Board of County Commissioners Summary Report

Case name: **PM22-006**
Arcadia Creek

RE: Arcadia Creek – Variance Requests to the Private Access

Re: Revised Variance Request Arcadia Creek
Technical Review Committee

PRELIMINARY LAYOUT PLAN

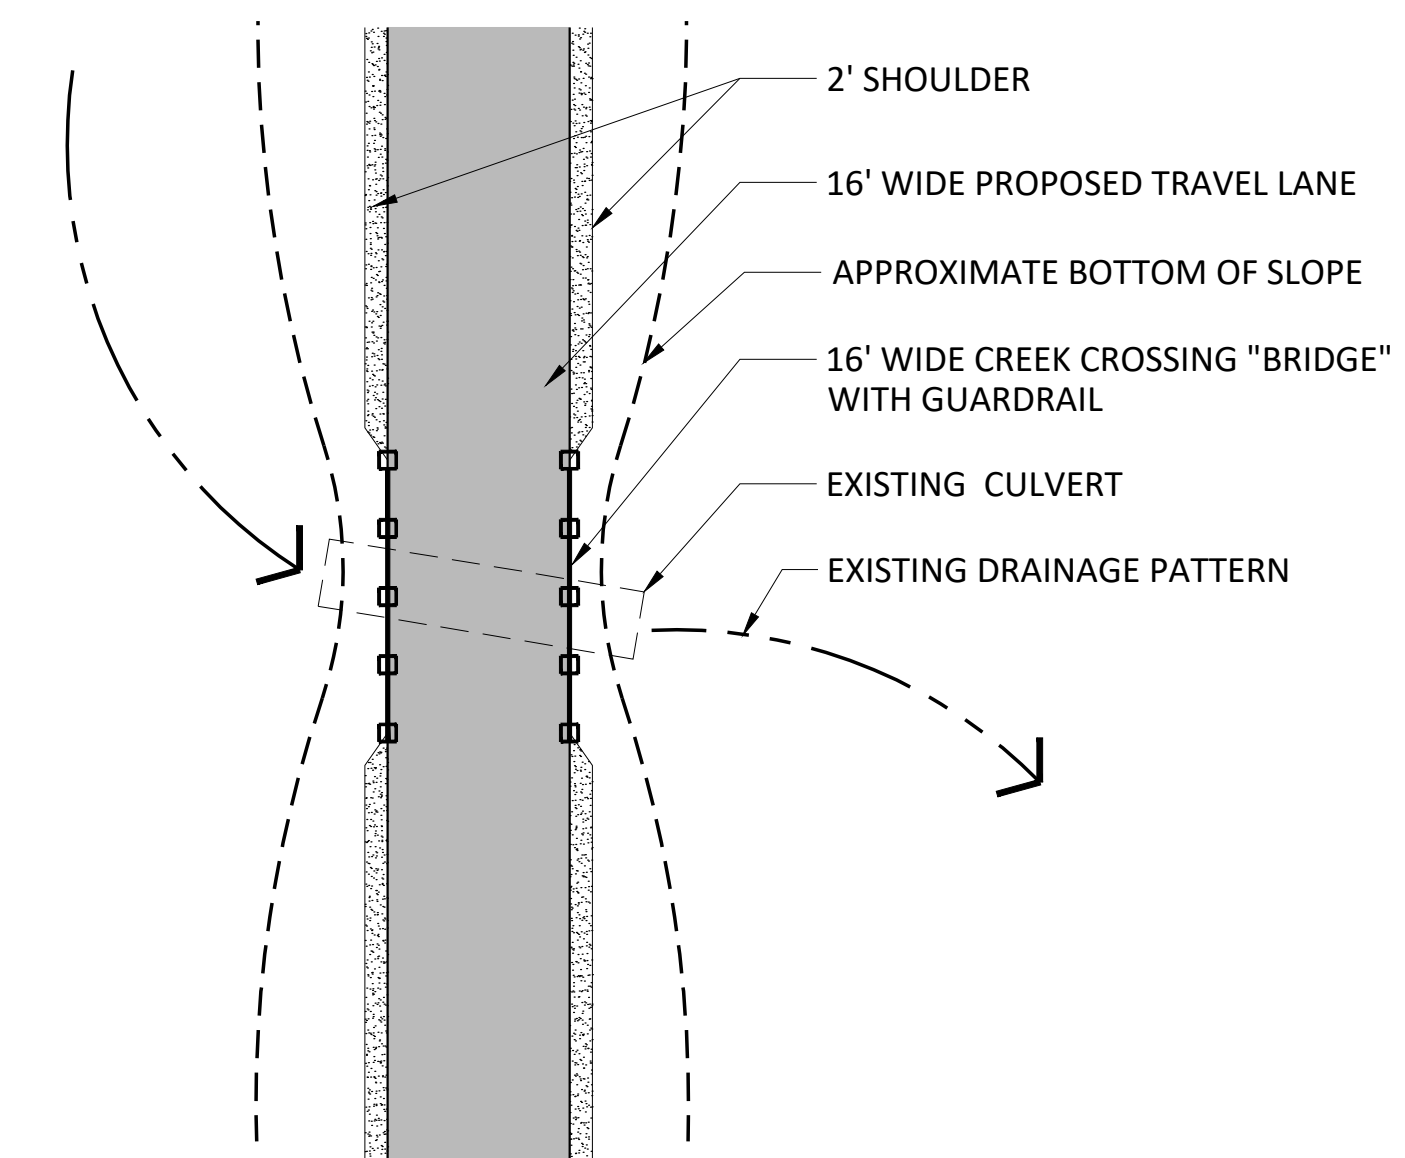
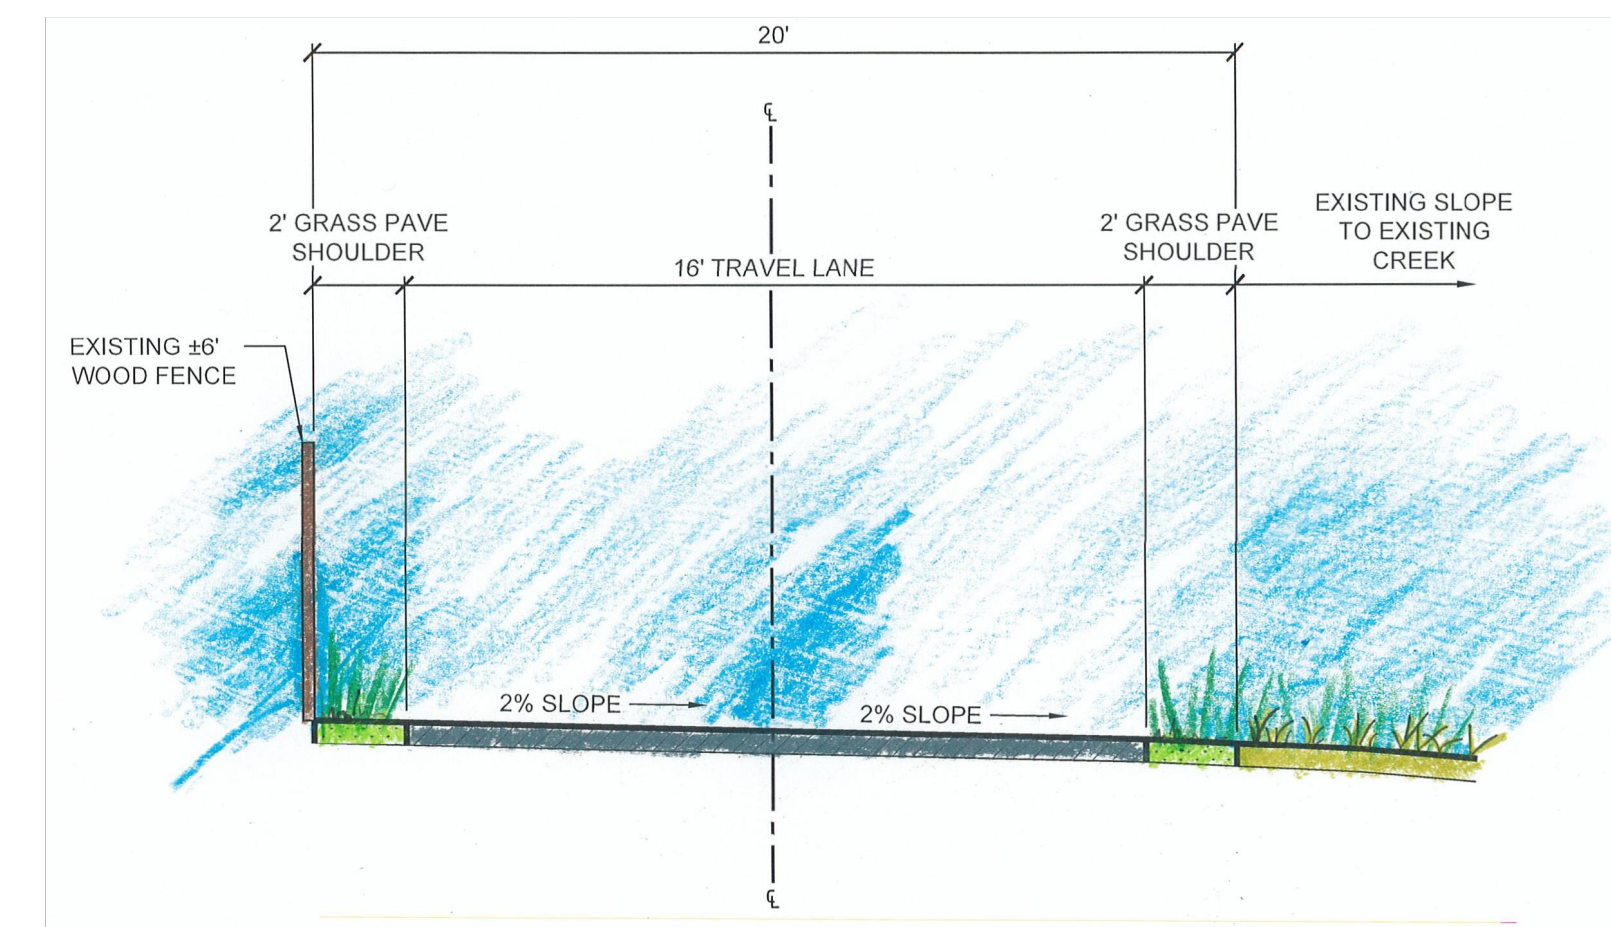
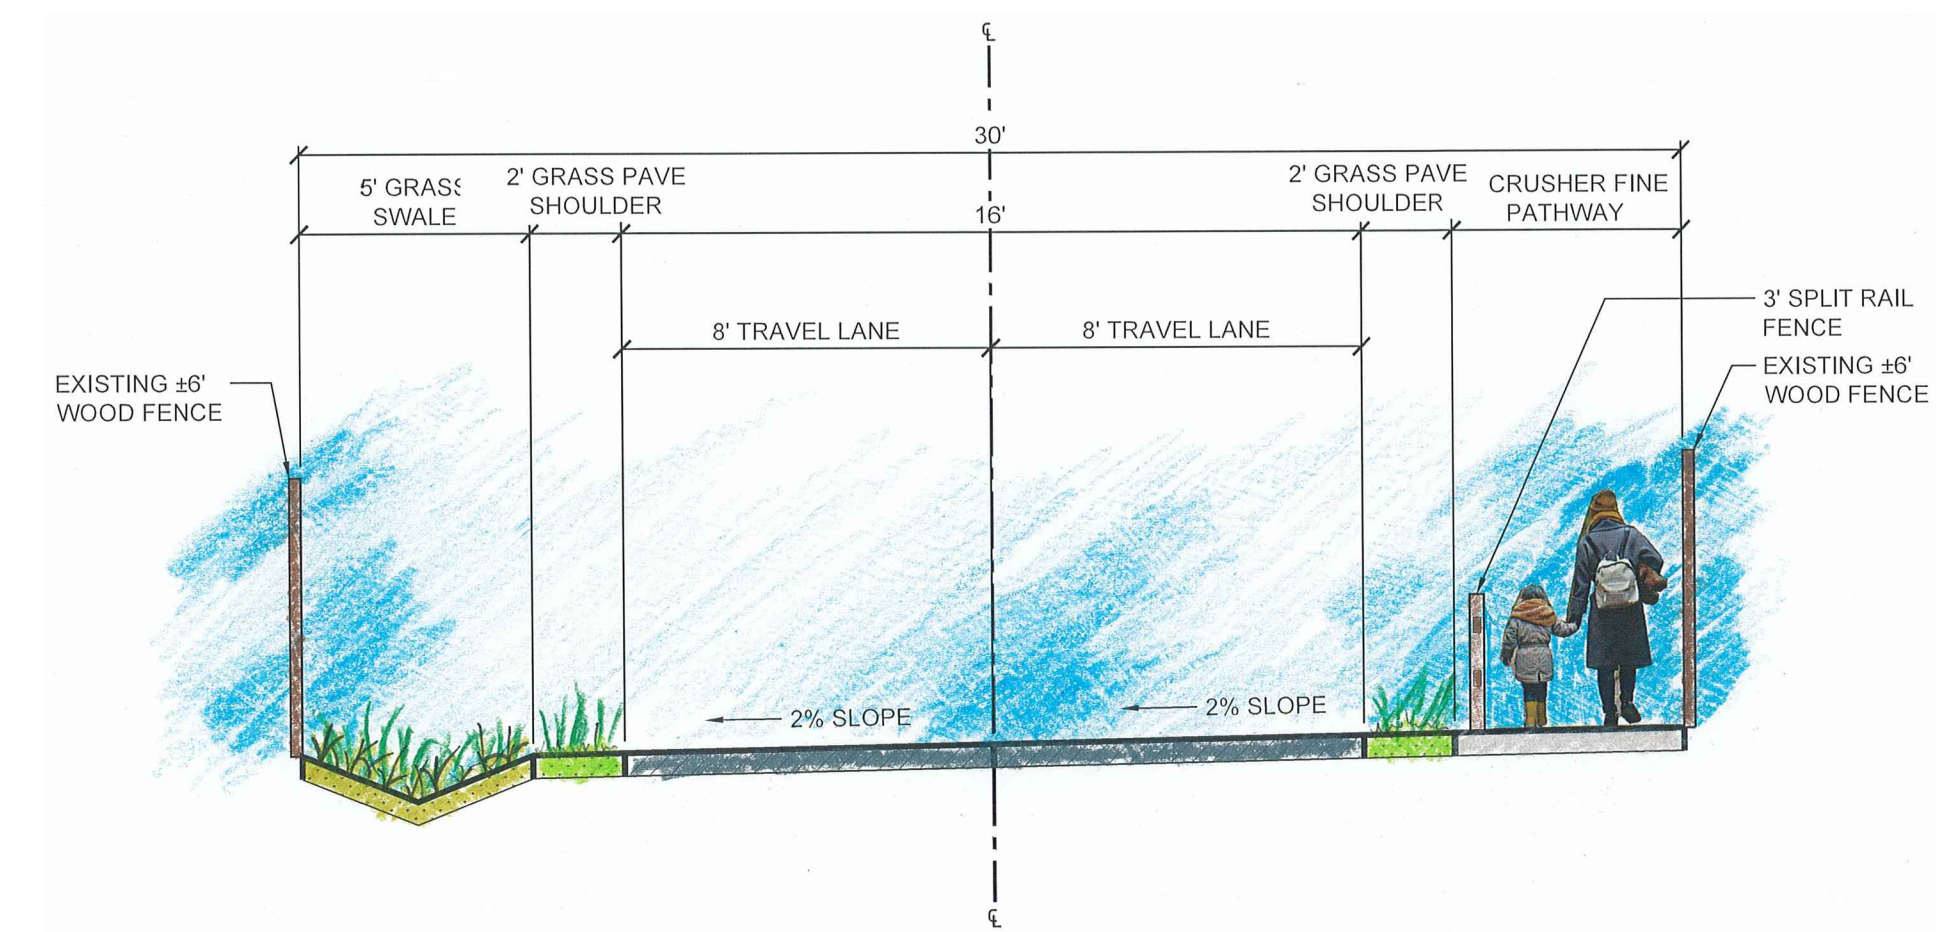
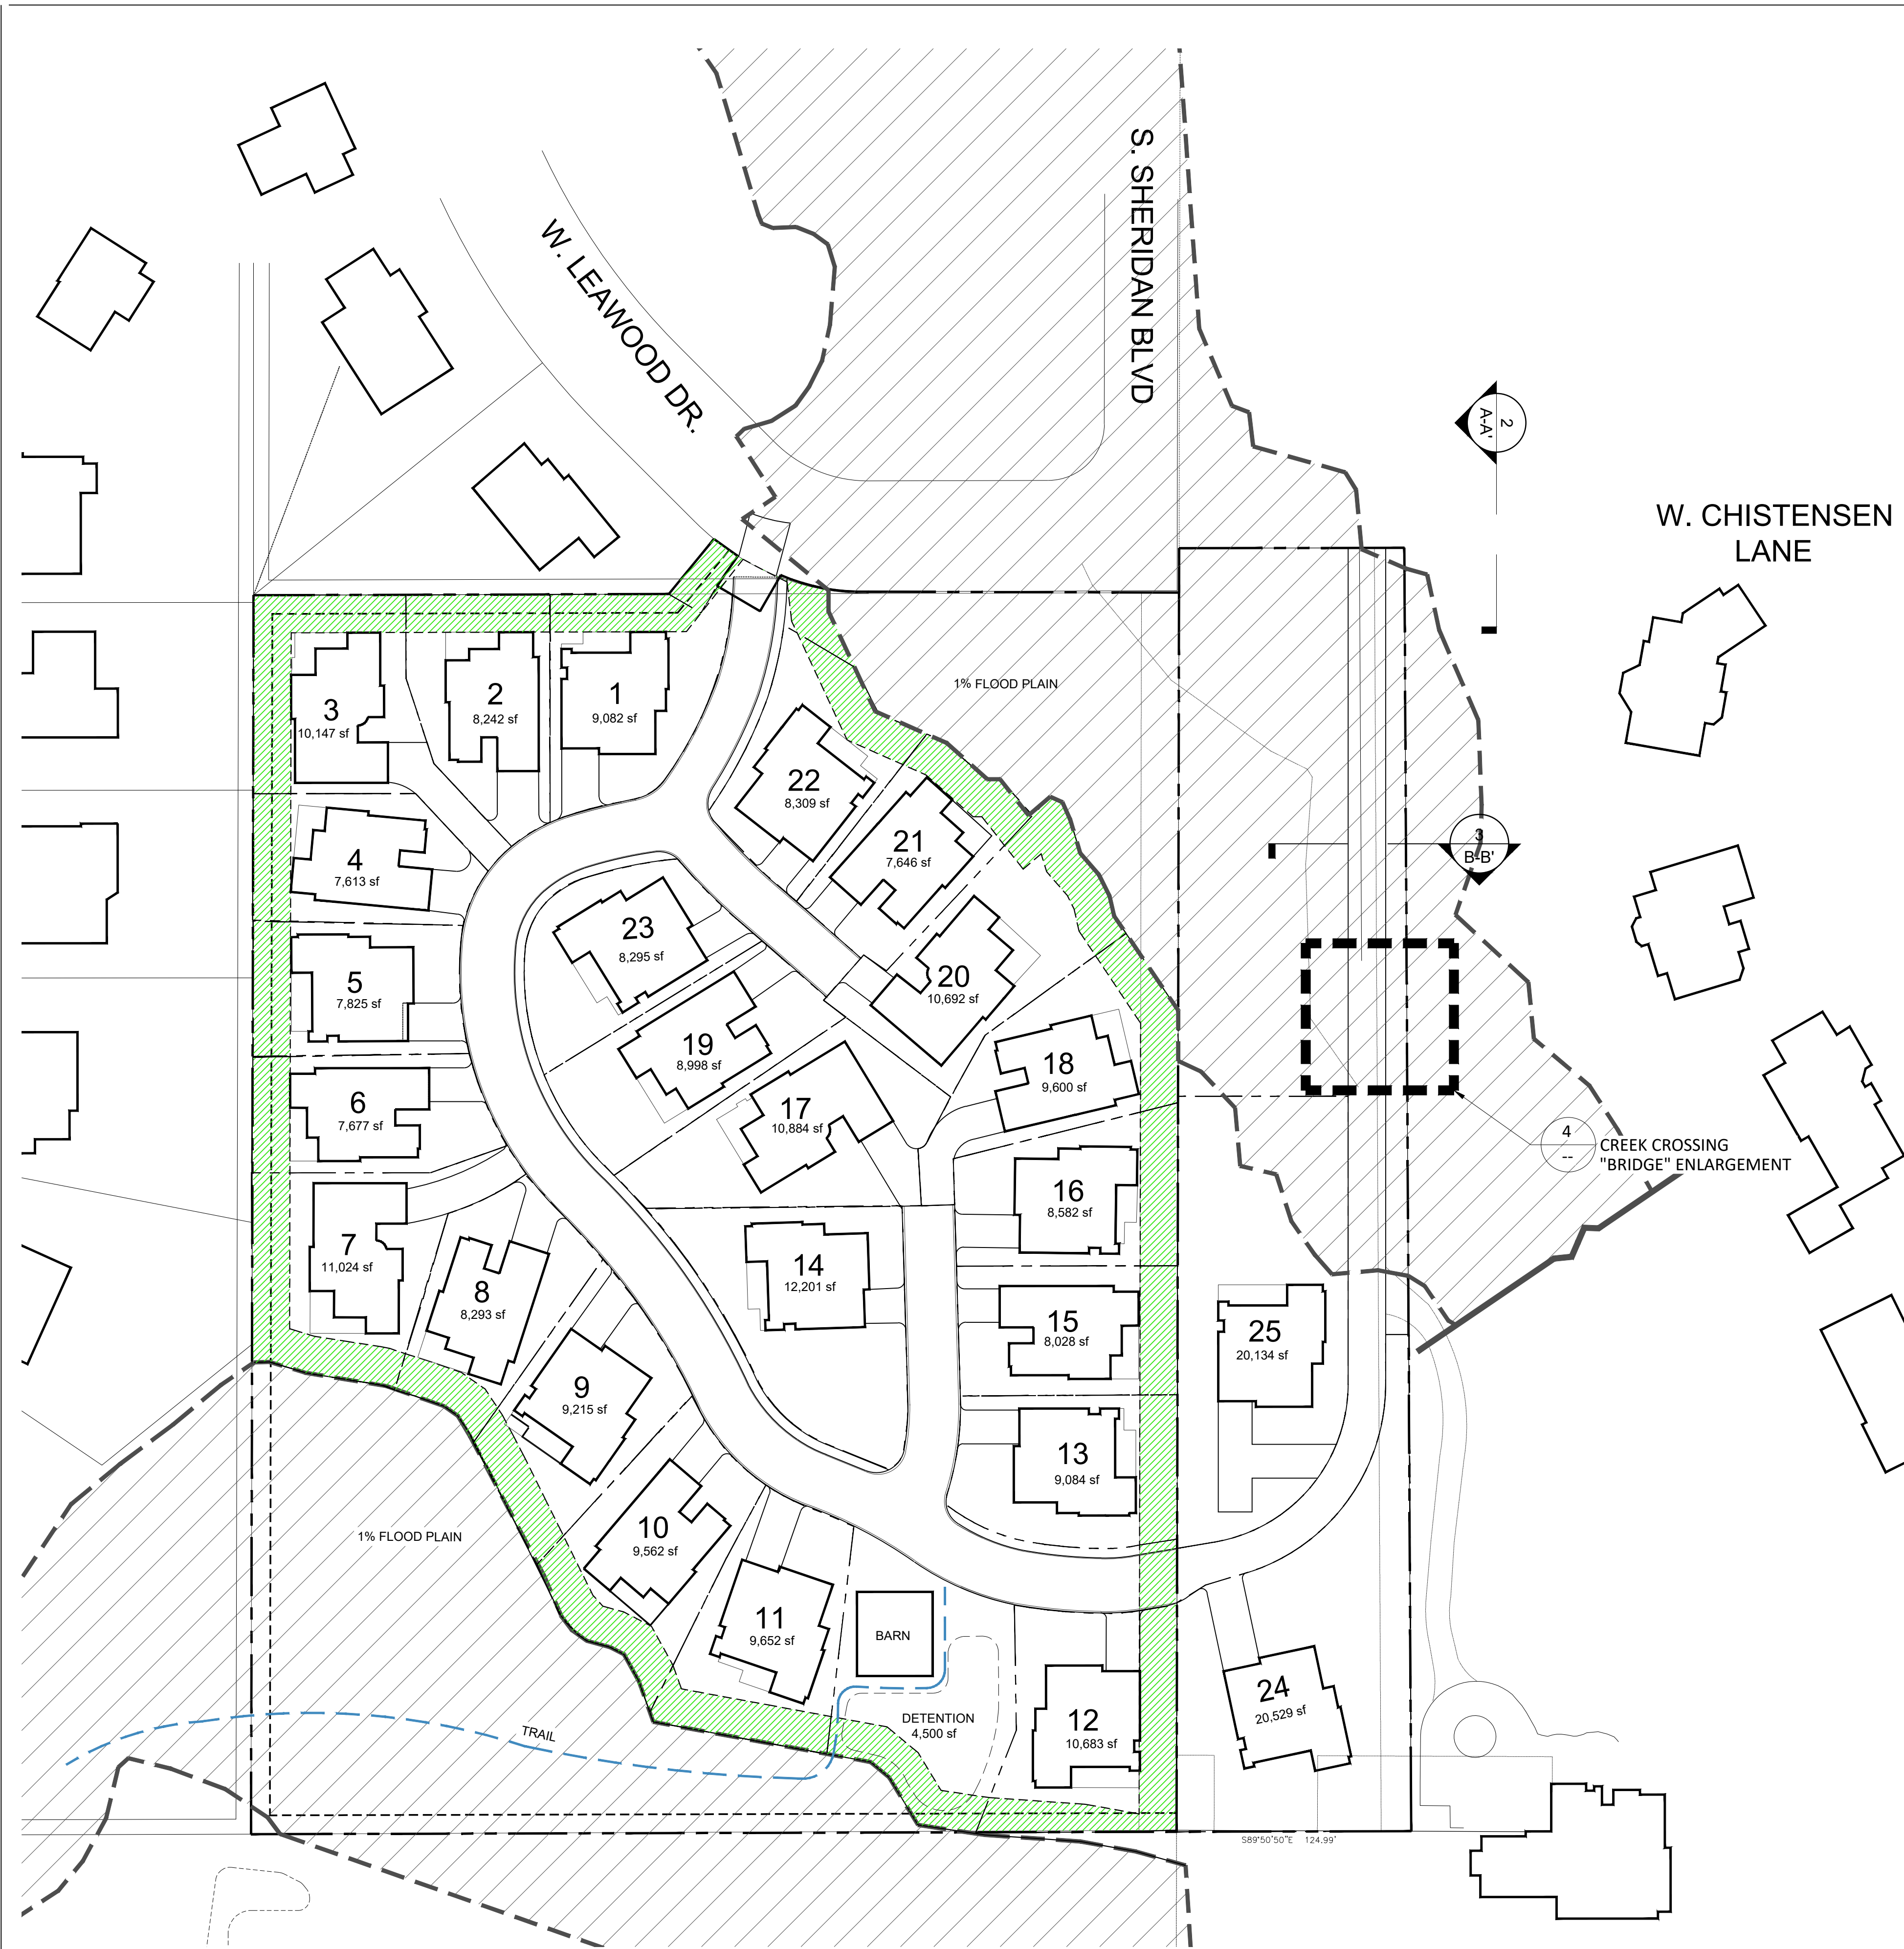
- The proposed cross section of the private access and the gate use plan must be reviewed by the Fire District, and the Fire District's approval is required.

- Recommends "No Parking" signs along both sections of W. Christiansen Lane be installed. This should also be determined and approved by the Fire District.

- Clarify the intention of the pedestrian path – whether the path is open to the public or private.
- Public Use Easement is required through the pedestrian path section.

- W. Christensen Lane is connecting directly to a State Highway. Arapahoe County will contact CDOT for the usage of the State Highway by the additional traffic generated from the Development.

- The stream crossing at the private access/Coon Creek should be updated if this private access is being upgraded pursuant to the Phase B Preliminary Design Report for Dutch Creek, Coon Creek, Lilley Gulch and Three Lakes Tributary. The Mile High Flood District (MHFD) makes the recommendation to the design of this stream crossing.

- No fence should be allowed within the floodplain. Arapahoe County's Floodplain Regulation prohibits the fence be placed within the 100-year floodplain.

- Concerns about the emergency access during a flood event. The Developer needs to verify if there is an access to a public road without going through a floodplain including the access in Jefferson County.

CHRISTENSEN LANE TYPICAL SECTION

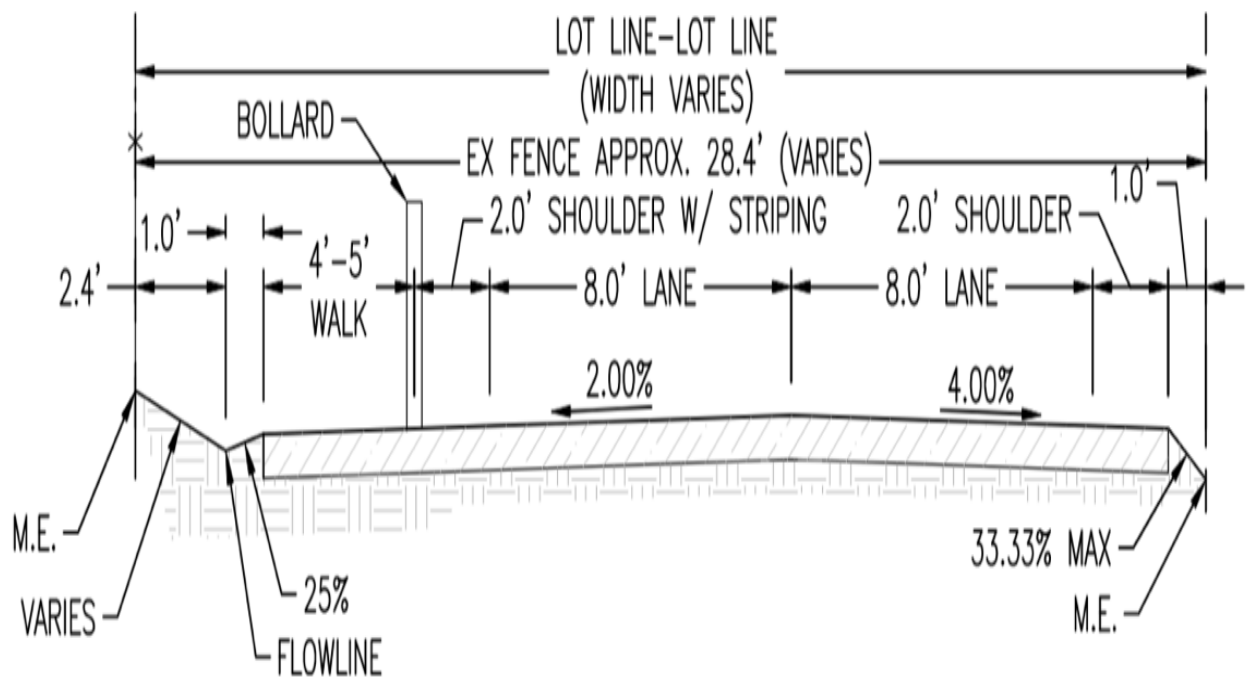
1. "The 4' proposed sidewalk/bike lane path as to the 5' as approved."
2. "Reason for the removal of the split rail."
3. "The slope of the cross-section in both directions(crown) is supposed to slope to the south as approved by TRC. TRC has no issue with the crown so far as the drainage works."
4. "Planning is advocating making the walking area distinct from the travel way. TRC recommends striping from the edge of the travel way. (Striping will span the 2' shoulder and the 4' sidewalk path."

Why did we change the slope of the cross-section in both directions (crown) instead of keeping the slope to the south as approved by TRC? TRC has no issue with the crown so far as the drainage works.

To the question that Planning is advocating making the walking area distinct from the travel way. TRC recommends striping from the edge of the travel way. (Striping will span the 2' shoulder and the 4' sidewalk path.

- The 4-5 feet proposed sidewalk/bikelane path.
- The proposed crown on Christensen lane. All drainage analysis as a result of this proposal should be addressed in the Drainage Report.

- Stripe the two shoulders on both sides of the road and the walkway path. All materials, striping should conform to MUTCD. South Metro Fire Rescue District should review amended cross-section for comments.
